Village of Bayside
9075 N Regent Road
Architectural Review Committee Meeting
June 7, 2021
Remote Teleconferencing, 6:00pm

**REVISED ARCHITECTURAL REVIEW COMMITTEE
AGENDA**

I have reviewed the above ground swimming pool for compliance with the Village's ordinances and have determined the following for consideration

VILLAGE CODE REVIEW

PLAT OF SURVEY

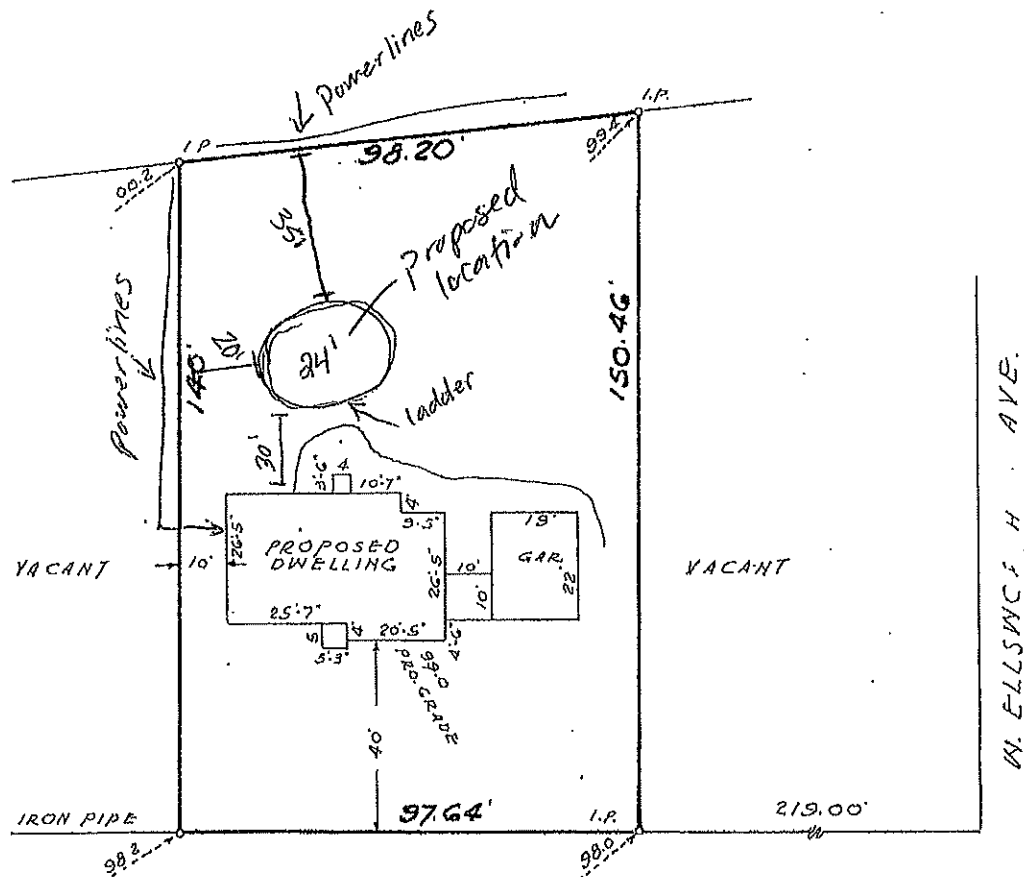
1. A survey has been provided showing the pool location meeting the required setbacks to the lot line and home. The survey is hand drawn, the ordinance **104-126(3)(D)(1)** requires a survey to scale
2. Owner states the pool will be not less than 50% below grade and the height of the pool will be at least five feet above grade with pool wall extender as required by ordinance
3. Owner did not show location of pool equipment but state it will be screened by existing trees.
4. Owner has drawn in location of power lines and will meet the minimum electrical code requirements
5. Earth tone pool will be harmonious with the neighborhood

The above ground swimming pool will meet the Village's ordinances when all information is verified.

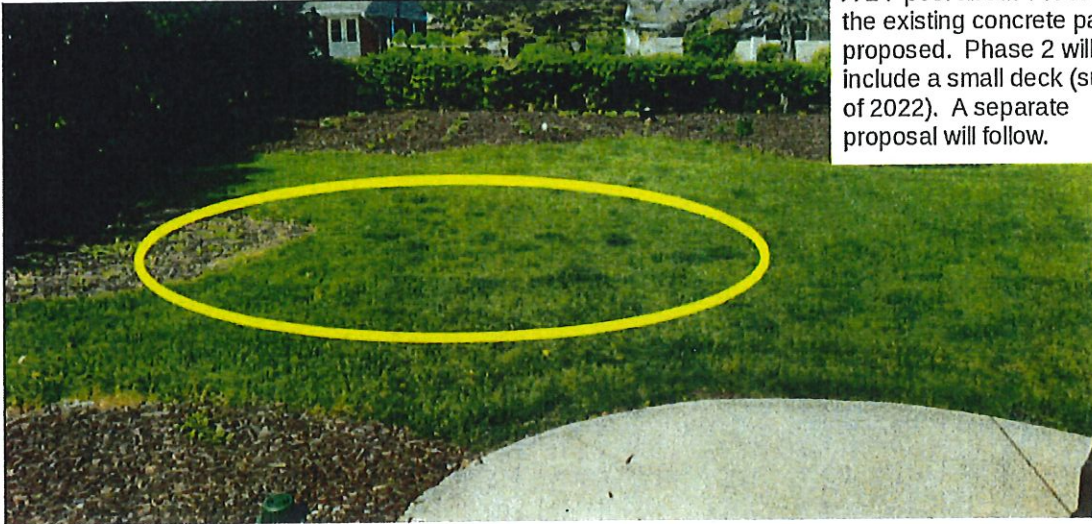
* Spoke with resident and confirmed that 50% of pool
will be below grade. - Leah Hofer

* Spoke with resident and confirmed mechanical systems
will be blocked by pool and existing coniferous trees. - fff

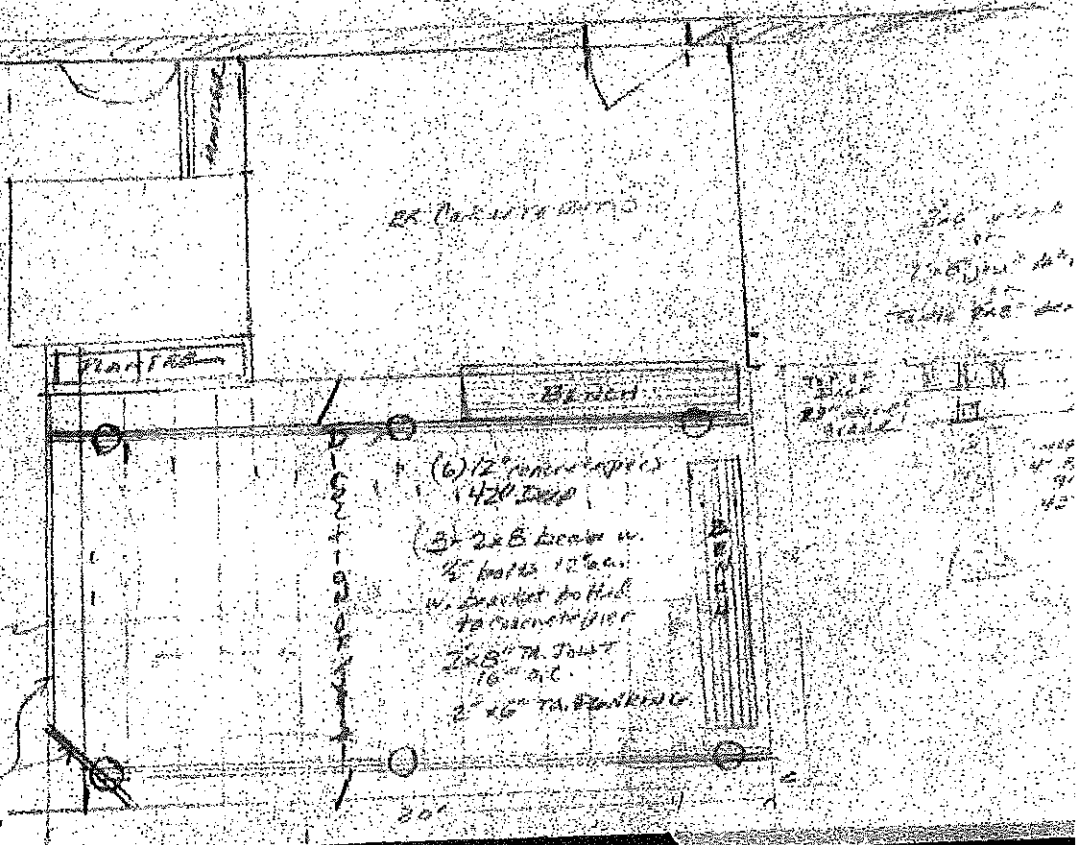
Sec. 104-4. - Accessory structures.

(m) Decks or patios are not considered accessory structures but shall not exceed 18 inches in height and 150 square feet without the approval of the architectural review committee.

Setbacks are code compliant

Building review is required. Submit complete set of construction plans for review before a building permit will be issued

PROJECT NAME: SCHLITZ AUDOBON, JASON
 PROJECT SITE ADDRESS: 1111 E BROWN DEER RD
 BAYSIDE, WI - MILWAUKEE COUNTY
 BUILDING SIZE: 5067M² (54,350 SQ FT)
 SHEET NAME: SITE PLAN

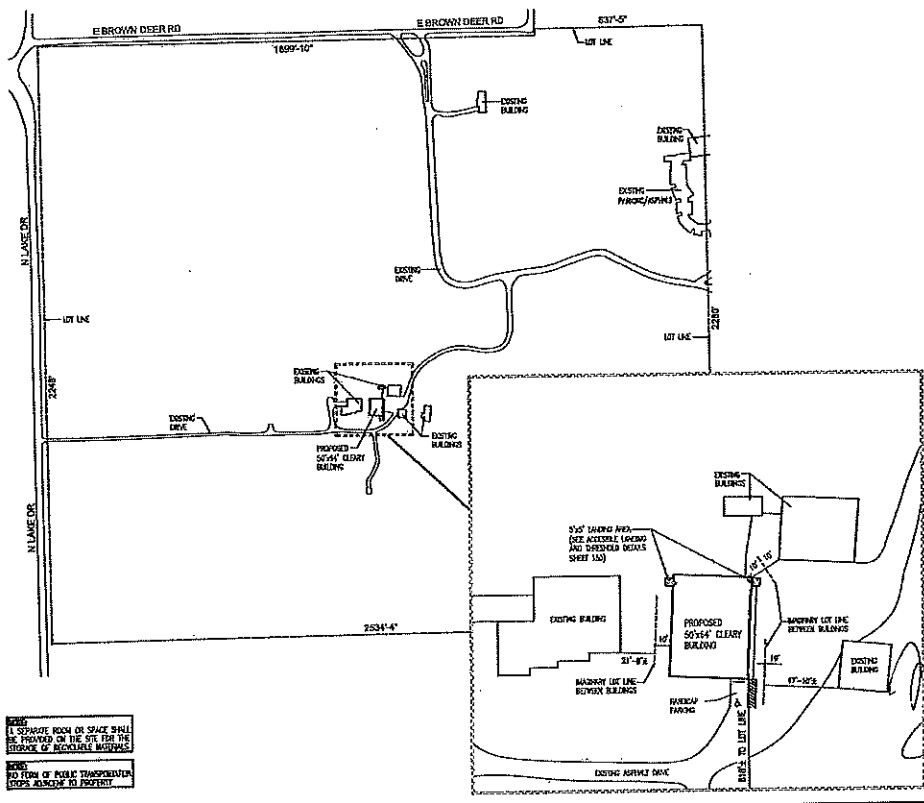
Architectural Review Committee shall make the final determination for approval of the proposed roof design relative to the existing nearby structures.

Building review is required. Submit plans with a completed SBD – 118 plan review application form.
